Amdt. to OL/ change to tech specs...
concerns changes in the organizational
structure of Sec. 6.0 of the tech specs
& corrects typographical errors in tech
specs.....

H. B. ROBINSON STEAM ELECTRIC PLANT, UNIT NO. 2
DOCKET 50-261

REQUEST FOR LICENSE AMENDMENT-REVISION OF TECHNICAL SPECIFICATIONS

Figure 6.2-1

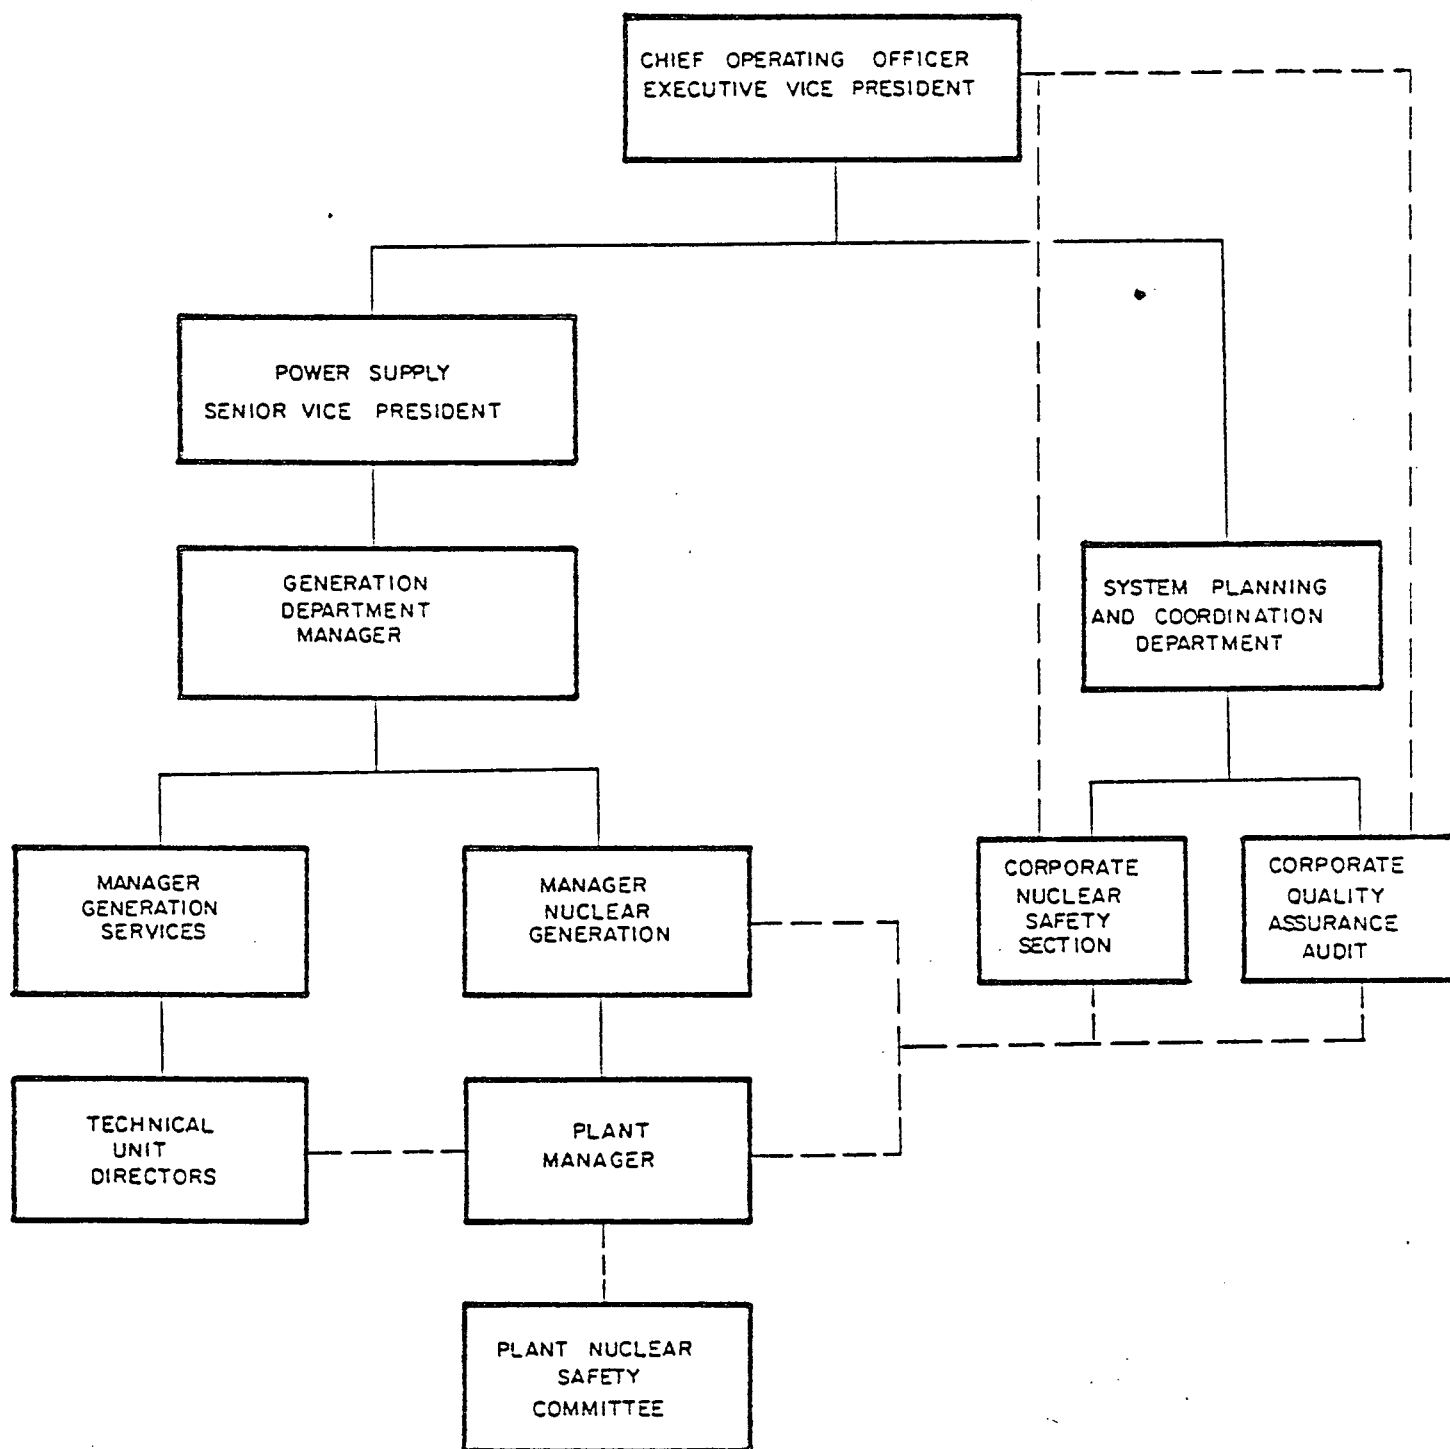
In accordance with the Code of Federal Regulations, Title 10, Part 50.90 and Part 2.101, Carolina Power & Light Company (CP&L) hereby requests a revision to the Technical Specifications for its H. B. Robinson Steam Electric Plant, Unit No. 2. This request reflects changes in the organizational structure of Section 6.0 of the Technical Specifications and corrects typographical errors in the Technical Specifications.

Attached are replacement pages for H. B. Robinson Steam Electric Plant, Unit No. 2 Technical Specifications which reflect these revisions. Appropriate changes are indicated by the vertical lines in the margin of the affected pages.
